TOWER DISTRICT SPECIFIC PLAN

**City of Fresno
Development Department, Planning Division**

7.0 ATTACHMENT TO THE ENVIRONMENTAL IMPACT REPORT ADDRESSING MODIFICATIONS TO THE DRAFT TOWER DISTRICT SPECIFIC PLAN

EXHIBIT "L-2"

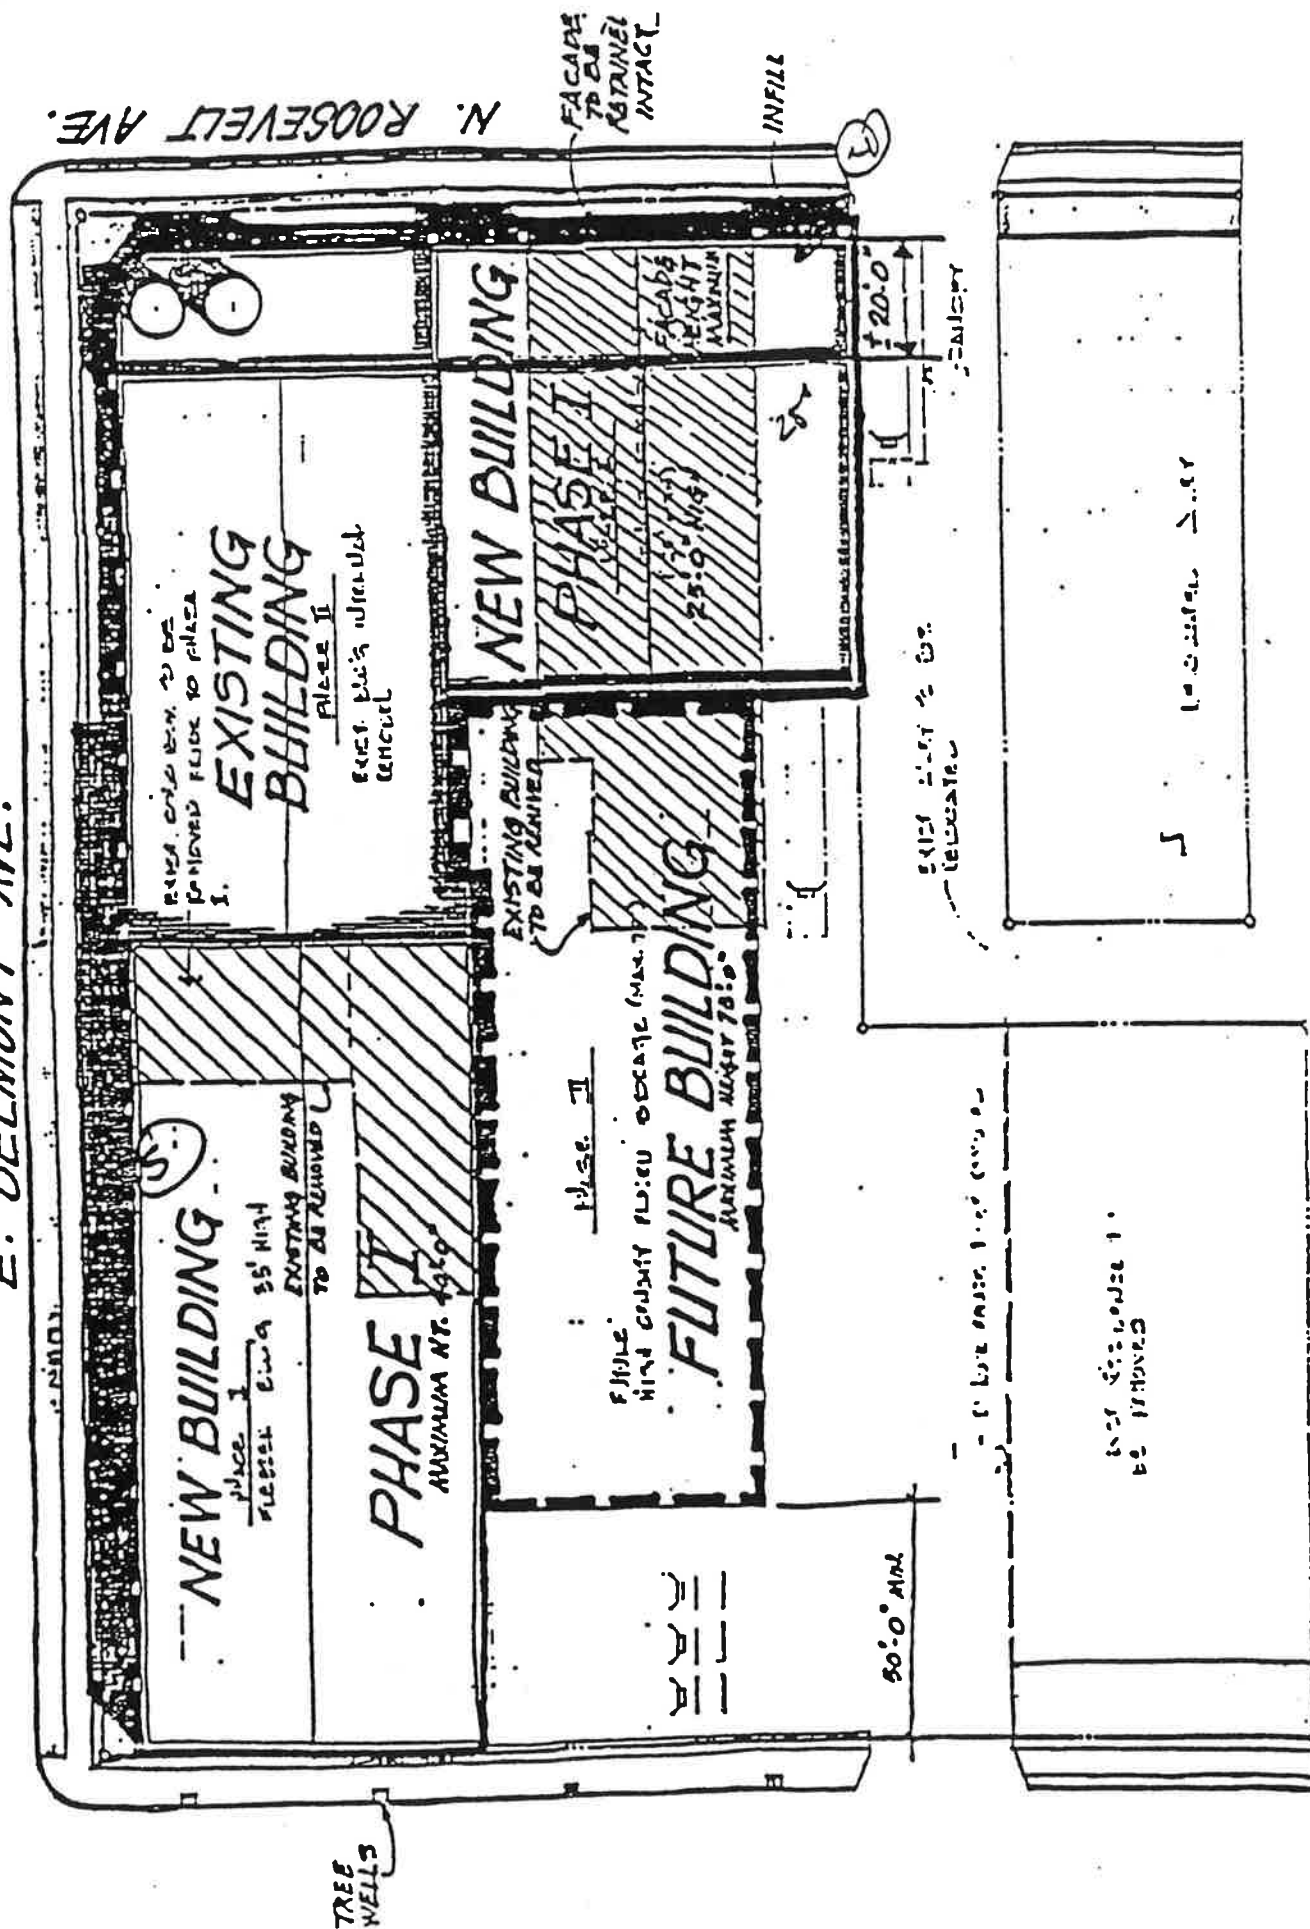
3. The new construction in the infill areas on the east side of the property shall be compatible with the existing structure as shown on Exhibit "L-2".

5. The new building to be constructed immediately west of the 30 foot existing building at the northwest corner of the sight as shown on Exhibit "L-1" shall be of a height equal to or slightly greater than the westerly portion of said building, but in no case higher than forty feet and shall be compatible with the existing structure to the east as shown on Exhibit "L-2".
